SUBMISSIONS REPORT

Yarren Hut Solar Farm

November 2020

Project Number: 19-754

Figure 1-3 Revised land and soil capability scheme

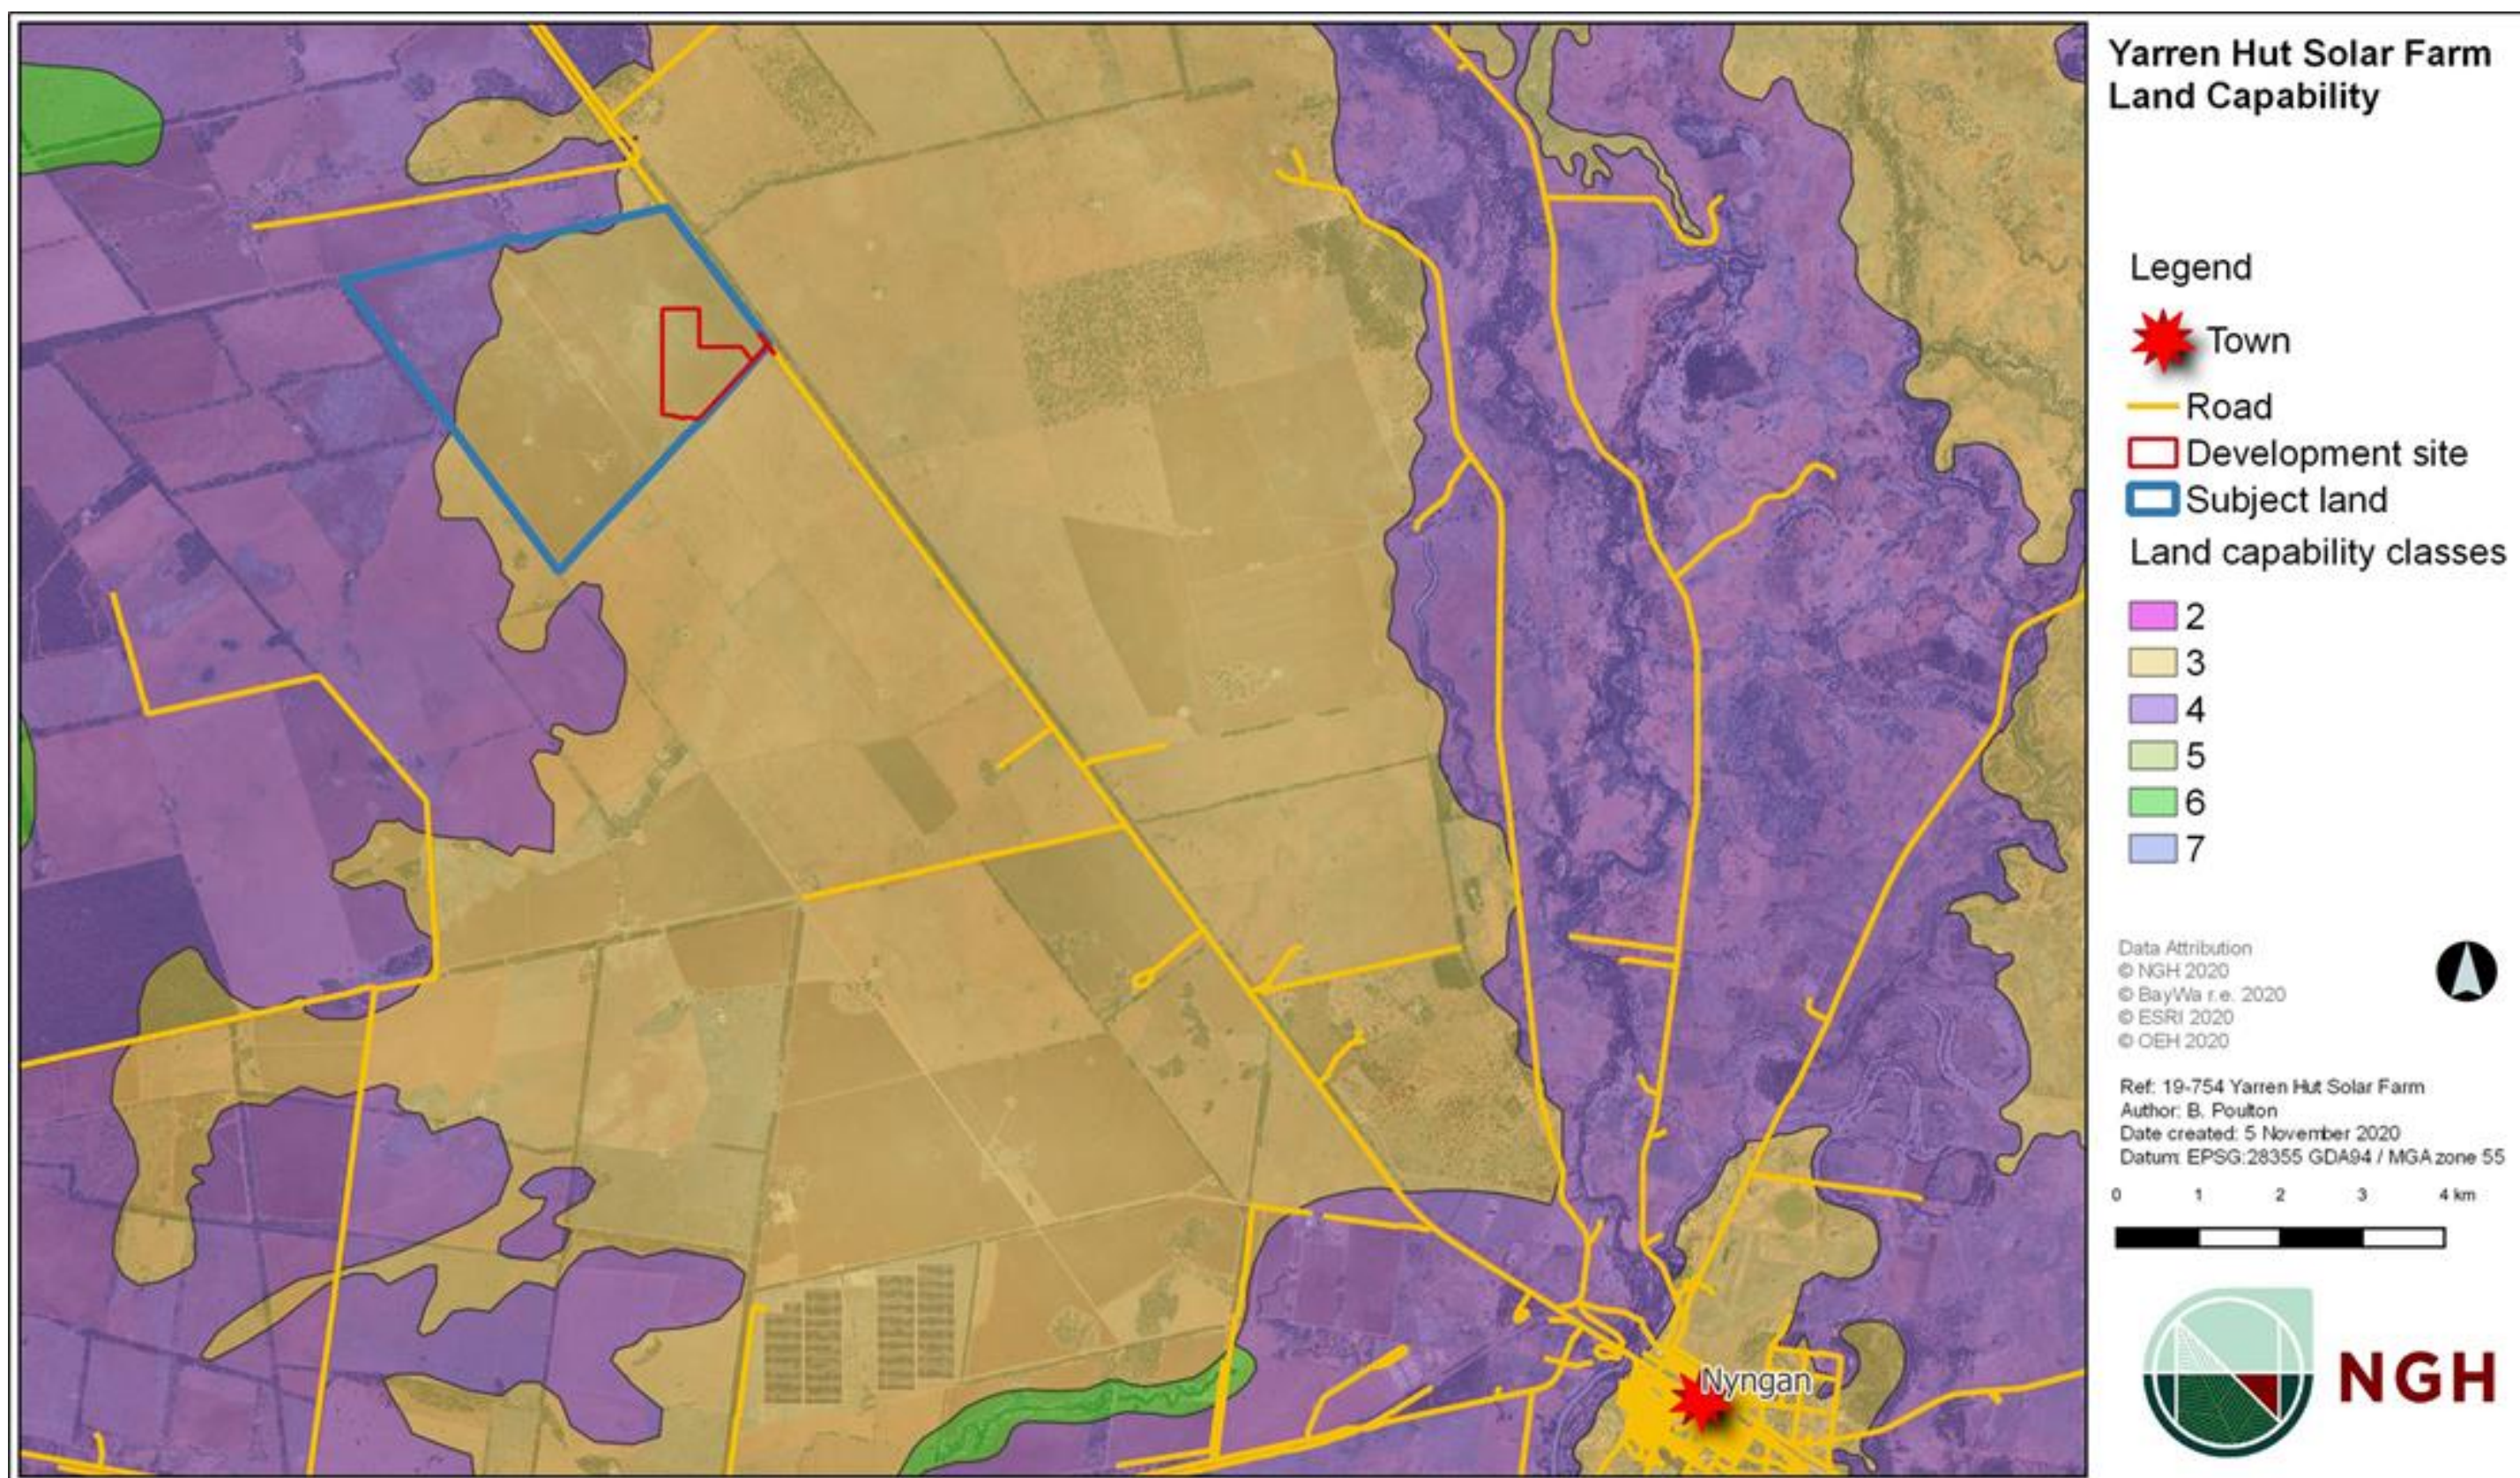
The large-scale solar energy guideline released by the NSW Government in 2018 dissuades developers from selecting high capability agricultural land (Classed 1 to 3), for large-scale solar developments. Since this land was considered Class 4 on inception, however, a soil assessment was completed for the development site.

Figure 1-5 Updated constraints map

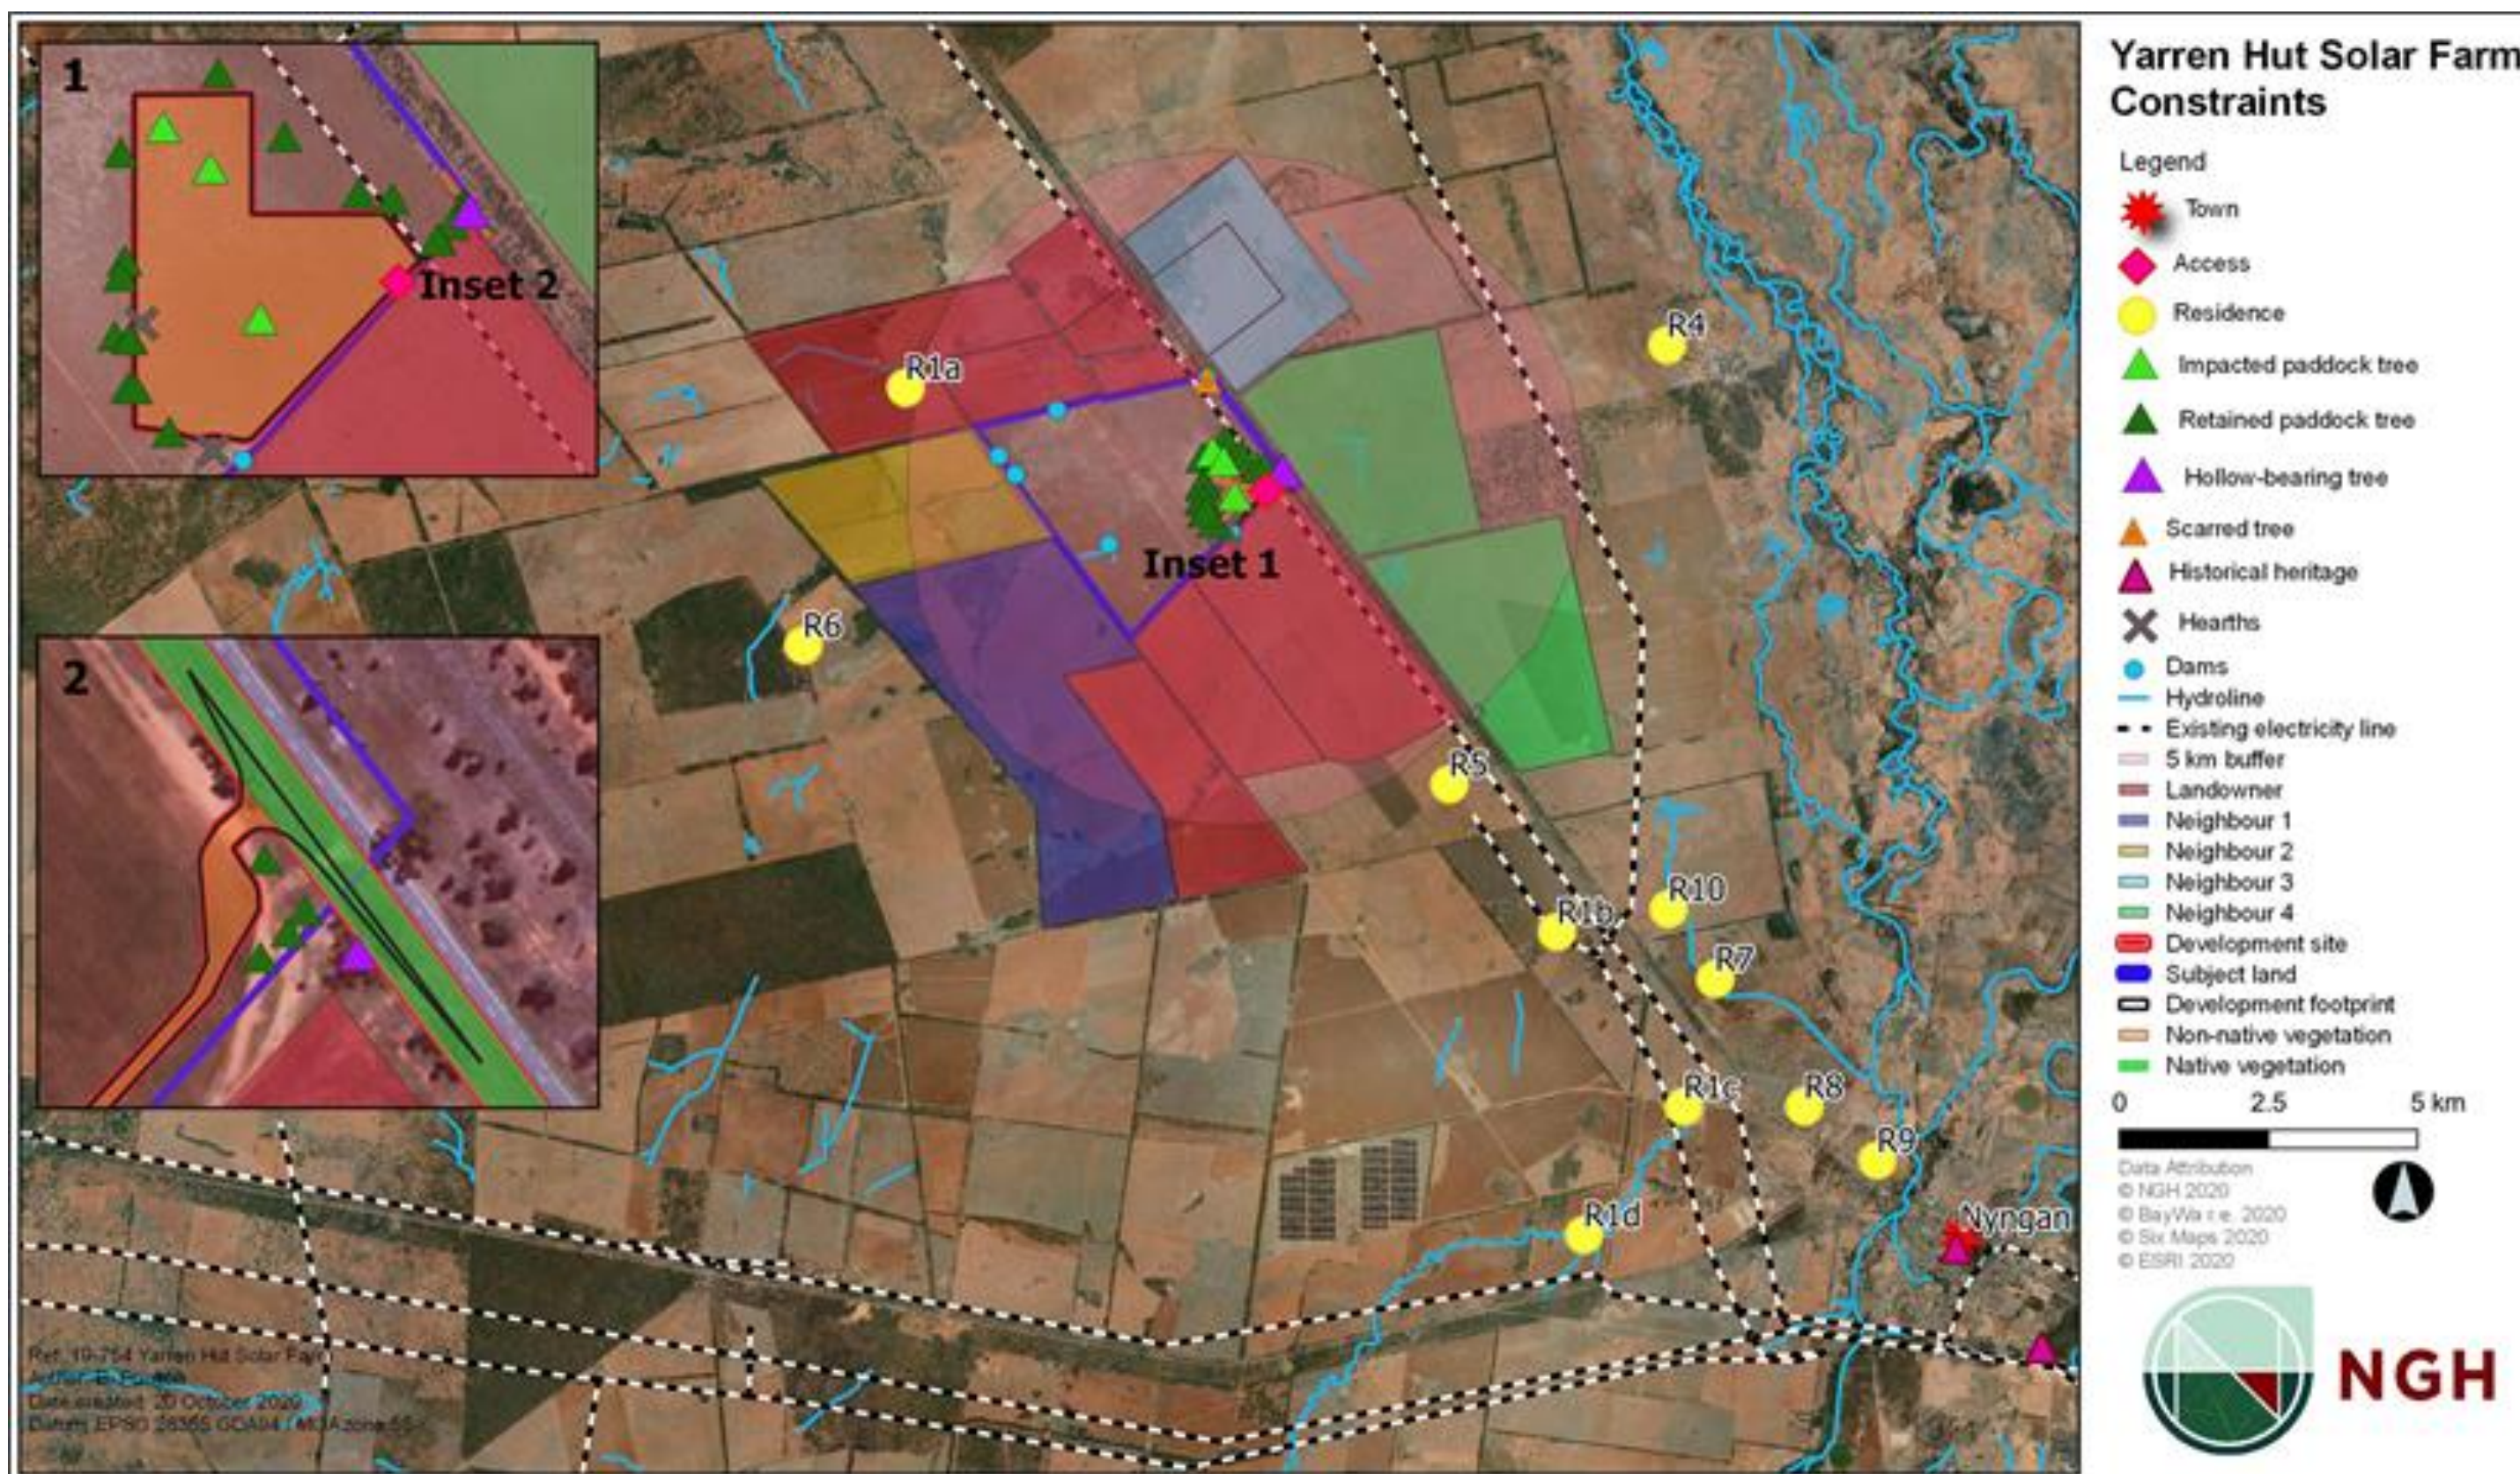
Issue	Response
1.1 Provide the following: a) a clear map at an appropriate scale which confirms the proposed location and extent of the footprint associated with the access treatment, correctly aligned with an aerial image. The polygon showing the footprint should be outlined only, with no shading. b) multiple photographs across the access treatment footprint to confirm the nature of the vegetation and structural elements in that area.	The mapping in the BDAR has been updated as requested to present the development footprint as an outline without shading. The GPS coordinates of all habitat features, and native vegetation polygons are ground-truthed, correctly georeferenced and appear on the maps in their proper location in relation to the development site boundary and the development footprint. The proponent considers that at the scale of the access treatment and the accuracy of recording GPS coordinates on the ground would create some alignment deviation with aerial photography. The proponent also notes that the georeferencing accuracy of aerial imagery reduces away from population centres. In any case, the proponent has committed to limit the impacts on native vegetation to the 0.08 ha of roadside vegetation and would avoid the removal of the one hollow-bearing tree recorded just outside the development footprint as shown in Figure 4-1 of the BDAR. Additional photographs of roadside vegetation are provided in section 1.3.2 of this Submissions Report above show sparse groundcover and a lack of mature trees.
